SUBJECT: Better Brite Chrome Interim Action Plans and Specs

SUBJECT: Better Brite Interim Action

Subject: Better Brite-Draft ROD/Interim Action Comments

Re: Comments on ROD Abstract
Better Brite Superfund Site

U.S.E.P.A.
 BETTER BRITE PLATING FACILITY
 DE PERE, WISCONSIN
 SITE MAP

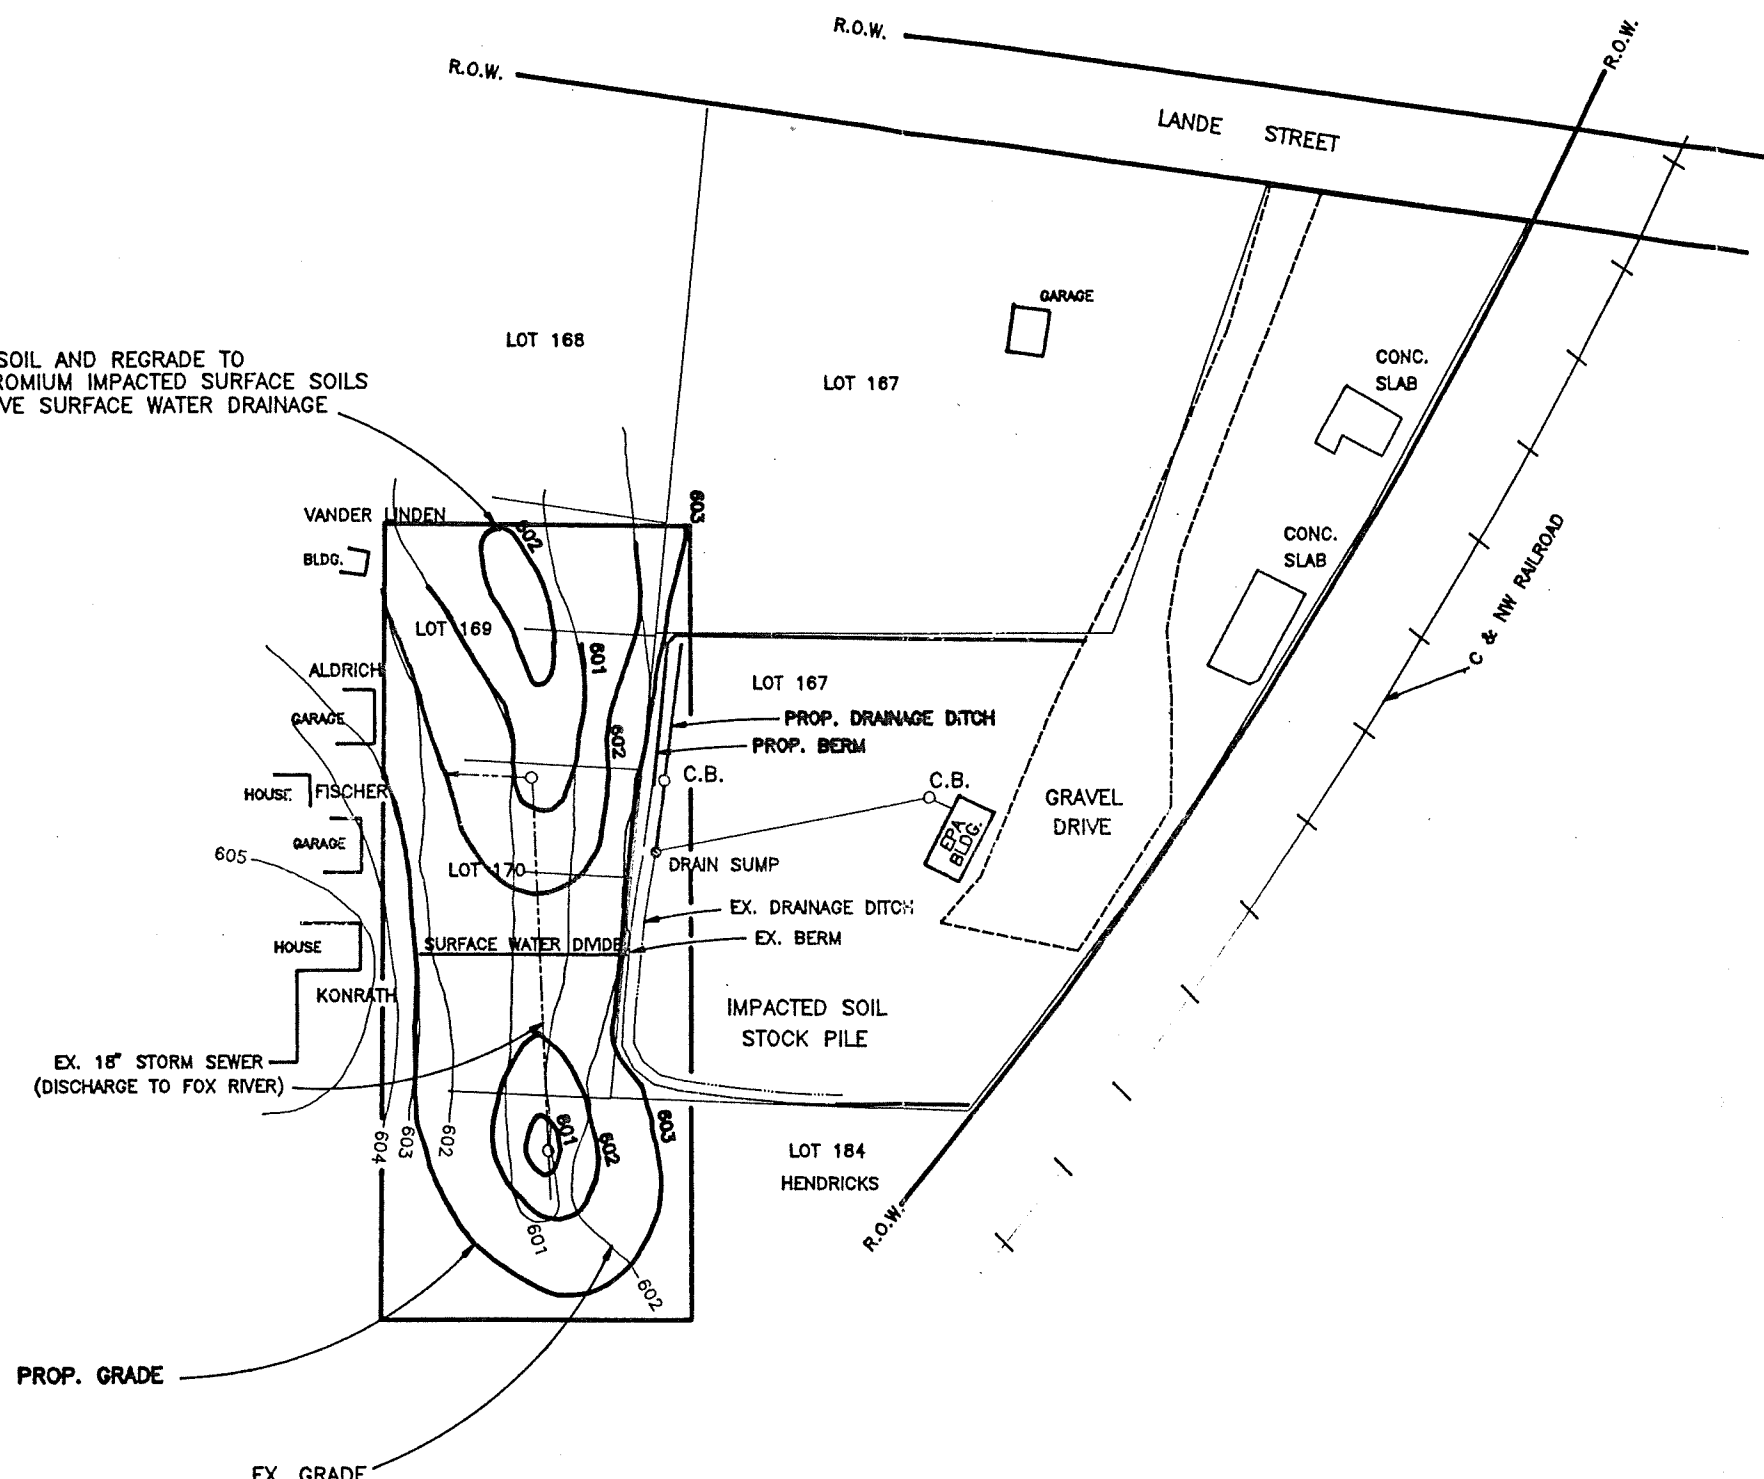
WW Engineering & Science, Inc., is proposing the implementation of three engineering design additions at the former Better Brite Plating Company site in De Pere, Wisconsin. These additions consists of extending the drain to the north as shown on the site map. The berm which is in place, would also be extended to enclose the southern, western & northern sides of the site. Lastly, a soil cap is being proposed to temporarily cover impacted soils on residential properties west and south of the facility grounds. The goals for each of these proposed additions are explained below.

Residential properties west and south of the Better Brite property will be regraded by the placement of a soil cap. The cover will be graded to direct surface water drainage to the existing storm water sewer catch basins, and prevent the surface water ponding which occurs

The catch basins located in the residential backyards are connected to an 18" diameter discharge line. The runoff entering this storm sewer is discharged to the Fox River with no pretreatment. The third function of the cap will be to provide isolation of surface water flowing to the drains from contacting the impacted soils below. This isolation will then reduce the risk of impacting the Fox River with chromium contaminated runoff. A rough estimate of the volume of soil needed to complete the cap as shown on the site map is 1,200 cubic yards.
